**Subject: San Francisco International Airport's Comments on the Land Use Consistency Determination for 271 El Camino Real Multi-Family Housing Project**

Thank you for notifying San Francisco International Airport (SFO or the Airport) regarding the Airport Land Use Commission's (ALUC) land use consistency determination for the 271 El Camino Real Multi-Family Housing Project (the Proposed Project) within the City of San Bruno. We appreciate this opportunity to coordinate with the ALUC in evaluating the Proposed Project.

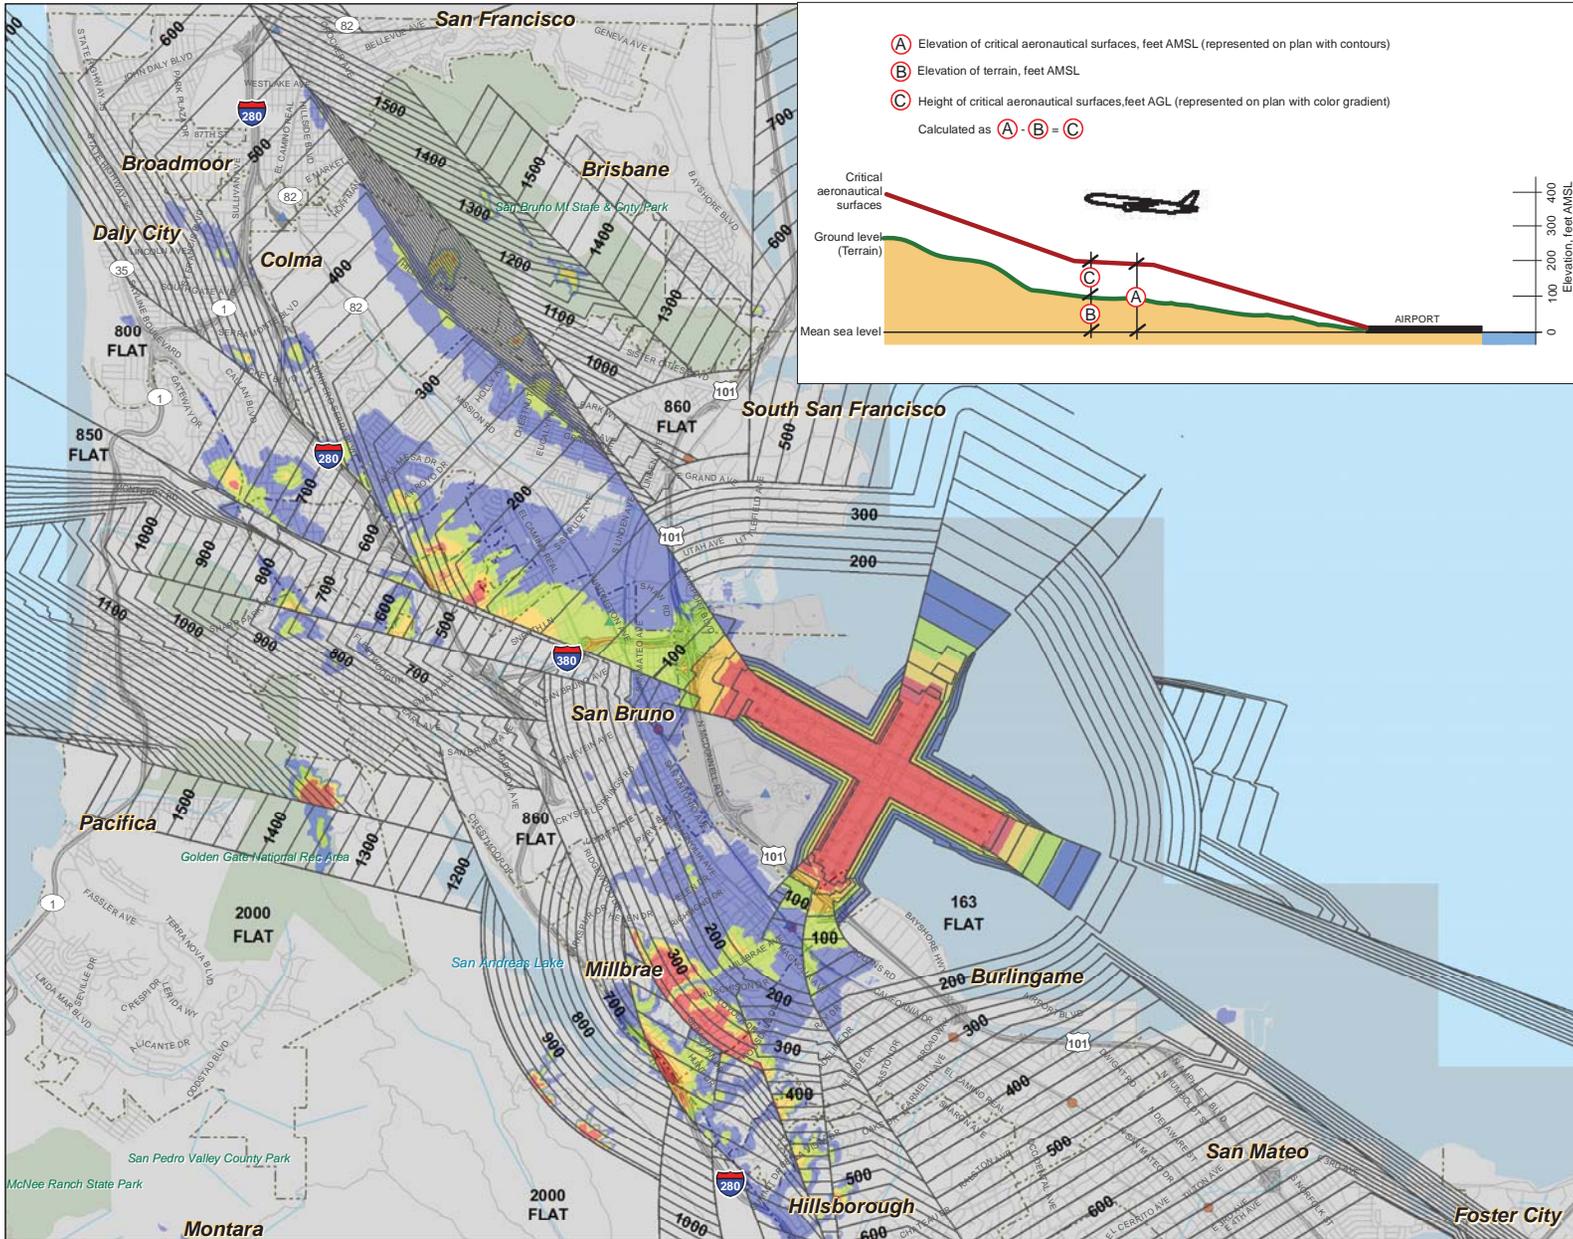
The Proposed Project is located beneath the critical aeronautical surfaces for Airport operations. As described in Exhibit IV-17 (see **Attachment A**) of the SFO ALUCP, the elevations of the critical aeronautical surfaces above the Proposed Project site are at least 150 feet above mean sea level, as defined from the 0-foot origin of the North American Vertical Datum of 1988 (AMSL NAVD88). Ground elevation at the Proposed Project site ranges from 47 to 60 feet AMSL NAVD88. While the drawings provided do not include a translation between the local vertical coordinate system and a standard vertical datum, the Proposed Project appears to be no taller than 56 feet tall, and so it would not appear to be incompatible with the airspace protection requirements of the SFO ALUCP.

The Airport emphasizes that no portion of the permanent structures, including any antennas, appurtenances, davits, or architectural parapets, may penetrate the critical aeronautical surfaces of the SFO ALUCP.
